| APPLICATION NO. | FILING DATE | FIRST NAMED INVENTOR | ATTORNEY DOCKET NO. | CONFIRMATION NO. |
|-----------------|-------------|----------------------|---------------------|------------------|
| 10/699,339 | 11/03/2003 | Stephen J. Seely | OCI 728 | 2510 |

**Advisory Action
Before the Filing of an Appeal Brief**

SEELY ET AL.

FIG. 1

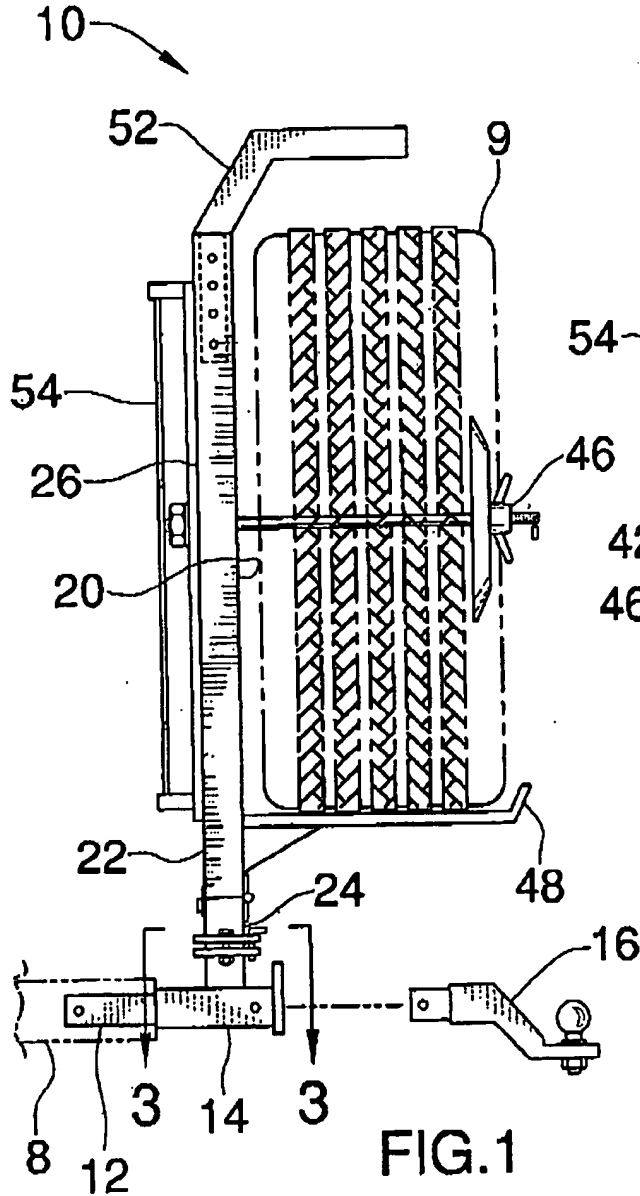
Continuation of 11. does NOT place the application in condition for allowance because: The original drawings filed on November 03, 2006 were objected under 37 CFR 1.83(a). The drawing must show every feature of the invention specified in the claims. Any structural detail that is essential for the proper understanding of the disclosed invention should be shown in the drawings according to MPEP 608.02(d). Corrected drawings in compliance with 37 CFR 1.121(d) were required in this application because applicant submitted incorrect drawings with application case number 10/699339. However, the "Replacement Sheet" of drawings filed on March 16, 2006 were objected to under 35 U.S.C. 132(a) because it introduces new matter into the disclosure. 35 U.S.C. 132(a) states that no amendment shall introduce new matter into the disclosure of the invention. The added material which is not supported by the original disclosure is as follows: 1. The Replacement Sheet drawings disclose the "flange" reference character #34 having a specific shape of having five (5) sides (See Figure 3). The specification on pages 4 & 5 do not recite "the flange" having five (5) sides. 2. The Replacement Sheet drawings disclose the head of the "bolt" reference character #38 having the hexagonal shape (See Figure 3). The specification on page 4 does not recite "the bolt" with the hexagon shape head. 3. The Replacement Sheet drawings disclose the "first portion" reference character #24 having the rectangular tubular cross-section (See Figure 3). The specification on page 4 does not recite "the first portion" having the rectangular tubular cross-section. 4. The Replacement Sheet drawings disclose the "pole" reference character #18 having the rectangular tubular cross-section. The specification on pages 4 & 5 do not recite "the pole" having the rectangular tubular cross-section. 5. The Replacement Sheet drawings disclose the "rigid panel" reference character #54 having a large square configuration (See Figure 2). The specification on page 5 does not recite the square shape. Furthermore, the specification on page 5 does not disclose the size of "rigid panel" in relation to the other components of the invention. 6. The Replacement Sheet drawings disclose the "pole" reference character #18 and the "guard" reference character #50 having the plurality of apertures on the surface of at least one side to suggest having telescoping means and adjustability means (See Figures 1 & 4). The specification on page 5, line 20 - 22 do recite "the pole" nor "the guard" having apertures along the side of "the pole" or "the guard" for telescoping means or adjustability means. 7. The Replacement Sheet drawings disclose the "locking means" with no reference character identification number assigned (See Figure 2). The specification pages 4 & 5 do not recite "the pole" and "the guard" have locking means. Therefore, due to the enclosed observations in the Replacement Sheet drawings filed on March 16, 2006, the Replacement Sheet drawings is object to under 35 U.S.C. 132(a) because it introduces new matter into the disclosure and 35 U.S.C. 132(a) states that no amendment shall introduce new matter into the disclosure of the invention. Therefore, the Replacement Sheet drawings filed on March 16, 2006 were not entered. Applicant is required to cancel the new matter in the reply to this Office action. In addition, the specification on page 4, lines 26 - 31 and page 5, lines 1 - 2 recites the first and second section with reference character #24 & #26. However, specification page 4, line 19 recites first portion with reference character #24 and the second portion with reference character #26. Appropriate correction is required.

* REPLACEMENT SHEET DRAWINGS DISAPPROVED
 * REPLACEMENT SHEET DRAWINGS NOT ENTERED
 ON JUNE 20, 2006. *L.V.*
